**TOWN OF NEWBURGH
PLANNING BOARD
TECHNICAL REVIEW COMMENTS**

PROJECT: CORTLAND COMMONS
PROJECT NO.: 2017-11
PROJECT LOCATION: SECTION 9, BLOCK 1, LOT 60
REVIEW DATE: 4 OCTOBER 2017
MEETING DATE: 5 OCTOBER 2017
PROJECT REPRESENTATIVE: JMC PLANNING & ENGINEERING

RE: JMC Project 16055
 Route 9W Retail
 Route 9W
 Newburgh, NY

Response to MH & E "Town of Newburgh Planning Board Technical Review Comments", dated 03/16/2017

Scale: NOT TO SCALE
 Date: 02/23/2017
 Project No: 16055
 Drawing No: COVER COVER

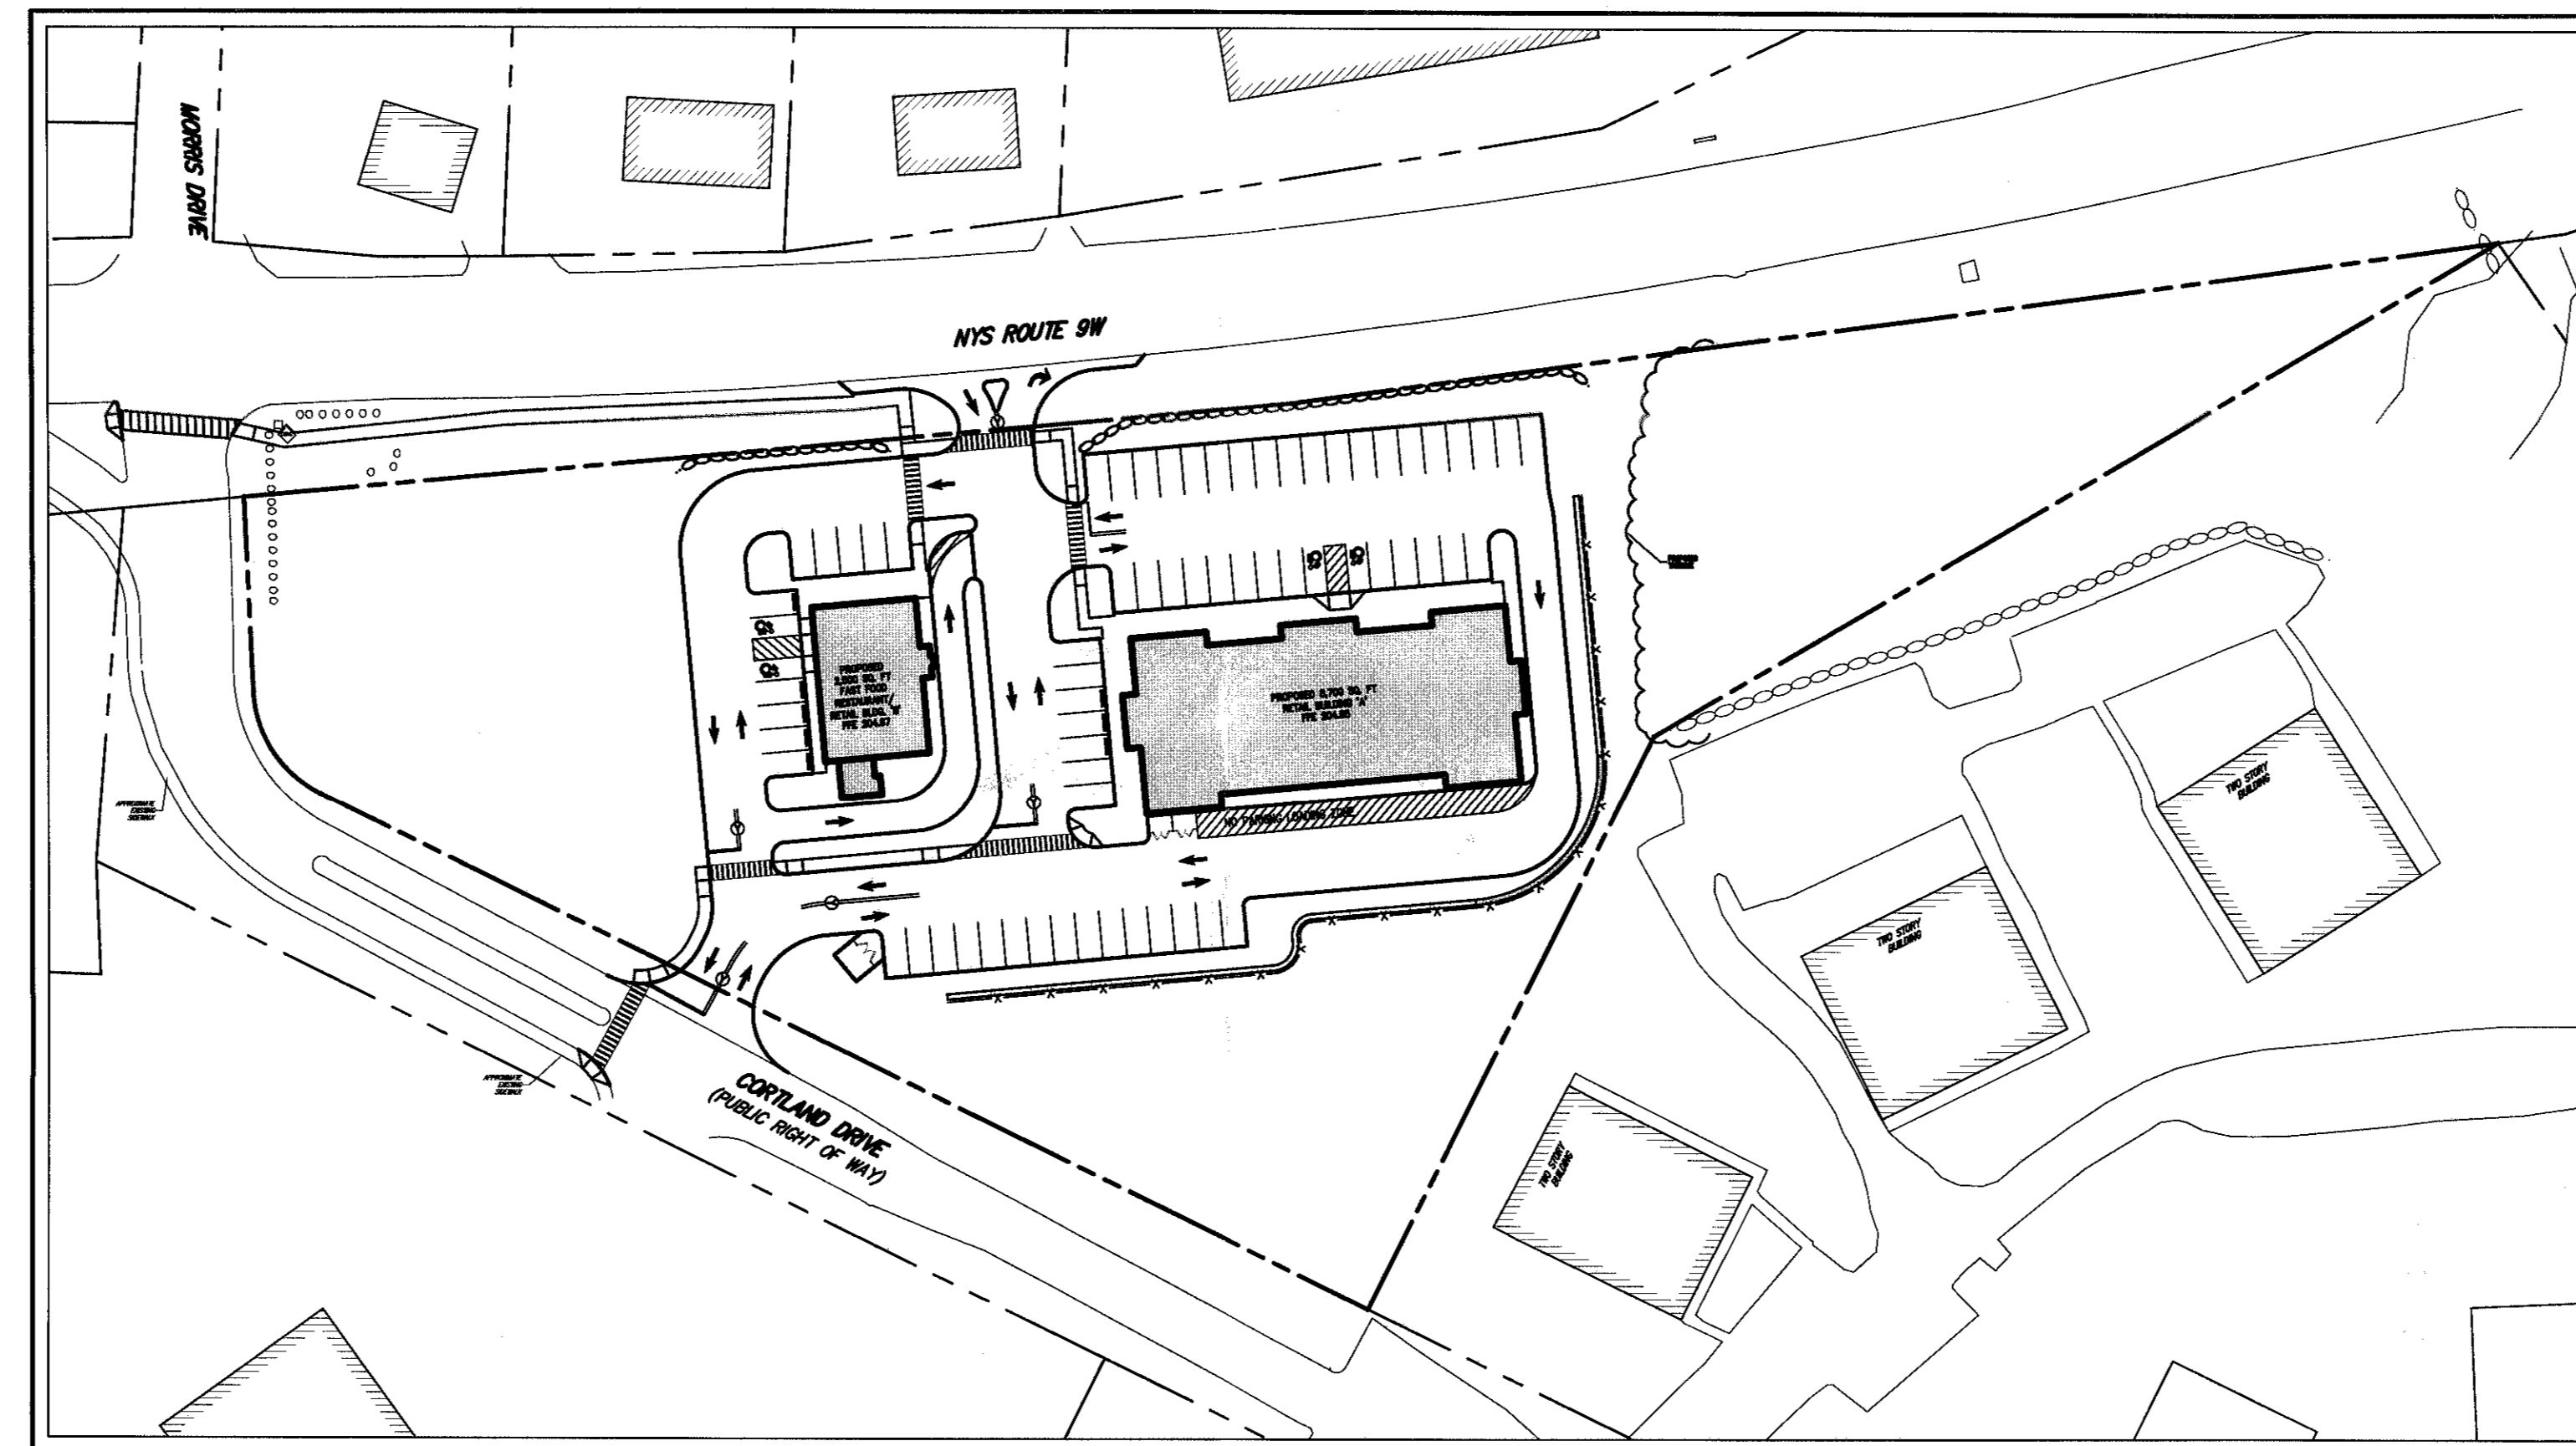
The zoning Bulk Table on sheet SP-1 identifies the front yard as 40 ft minimum and proposed 59. Section 185-18 - Exceptions to District Regulations(4)(b) requires front yards abutting all State and County Highways be at least 60 feet in depth.

Drawn: RC Approved: JS
Scale: NOT TO SCALE
Date: 02/23/2017
Project No: 16055
Sheet No: SP-11
Drawing No: SP-11

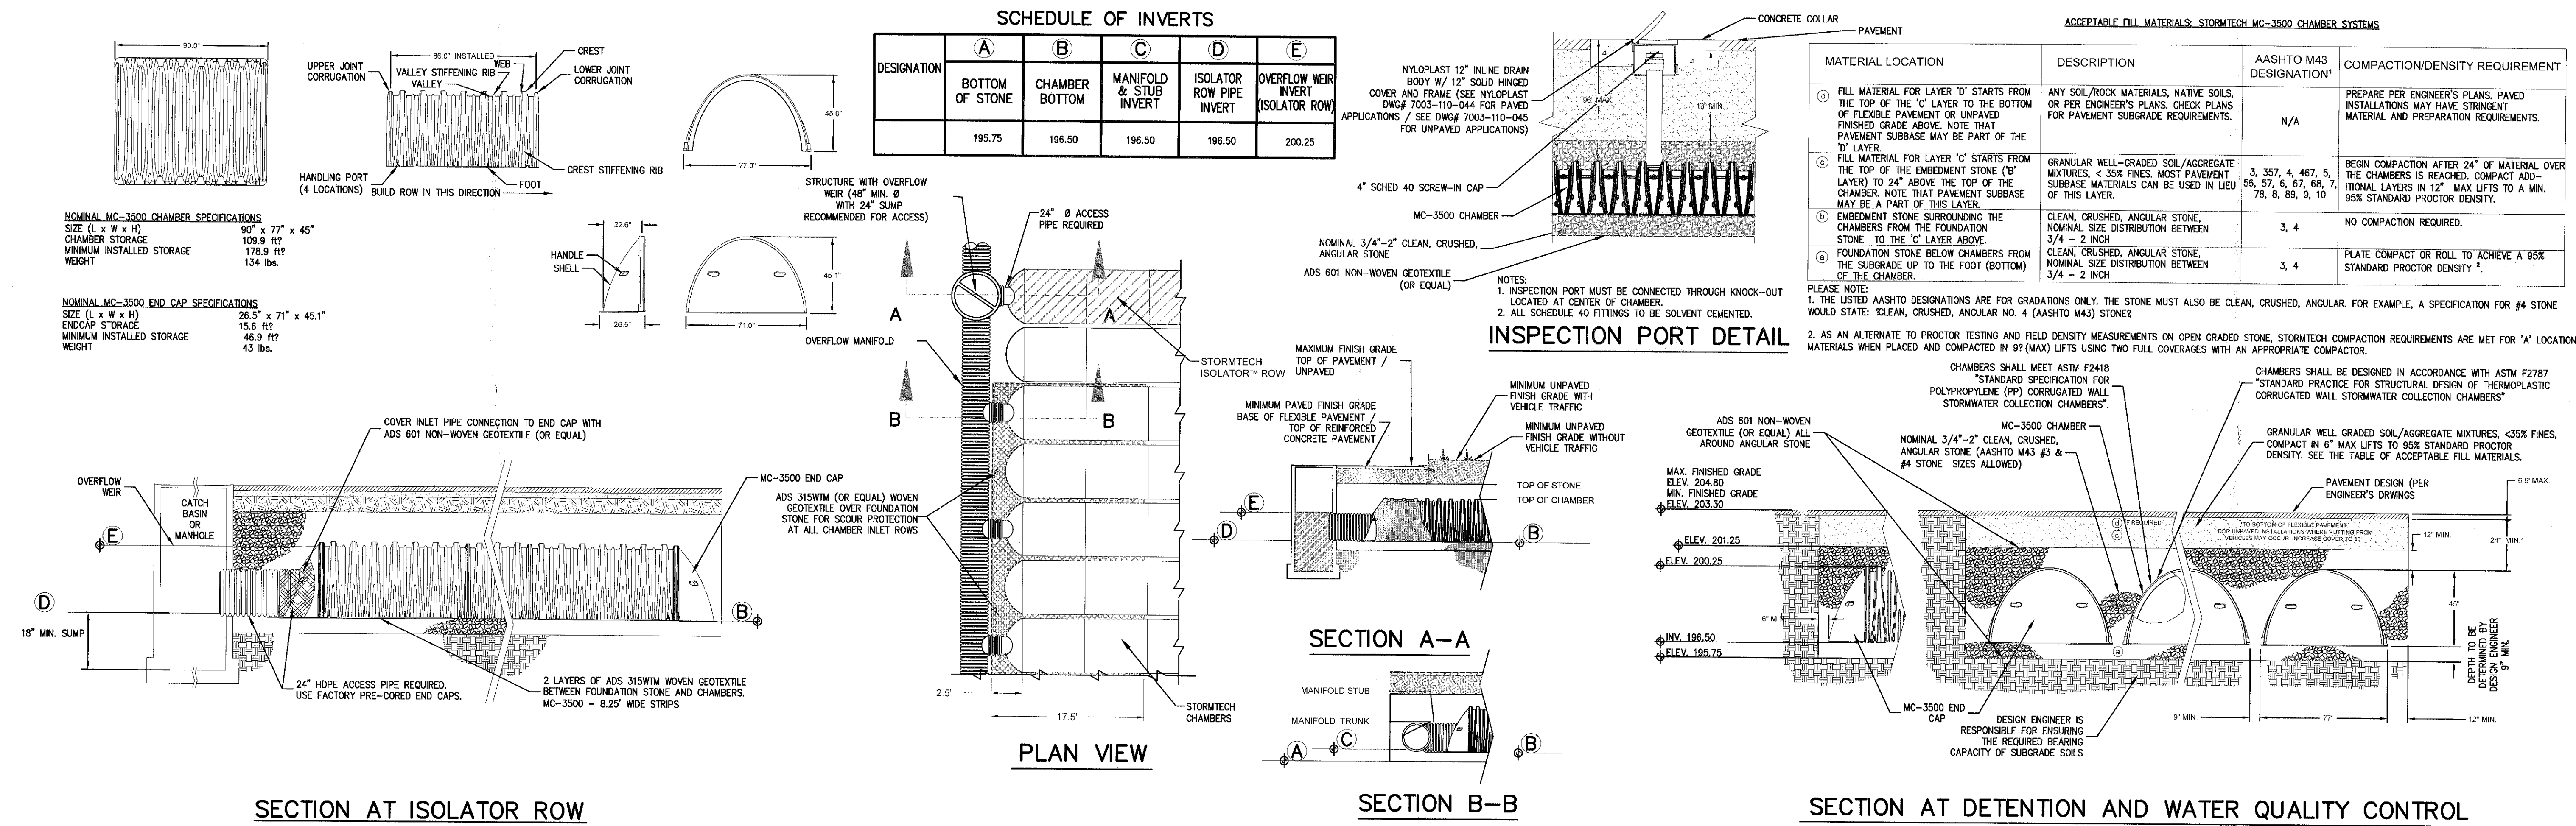
Sheet SP-11 contains anchor and thrust block details and charts. Town of Newburgh requires restraint joint pipes. Thrust blocks are not permitted.

Thrust blocks have been removed from the detail sheet, "Field Lok" restraint gaskets have been specified on Drawing SP-5 "Utilities Plan". See General Notes.
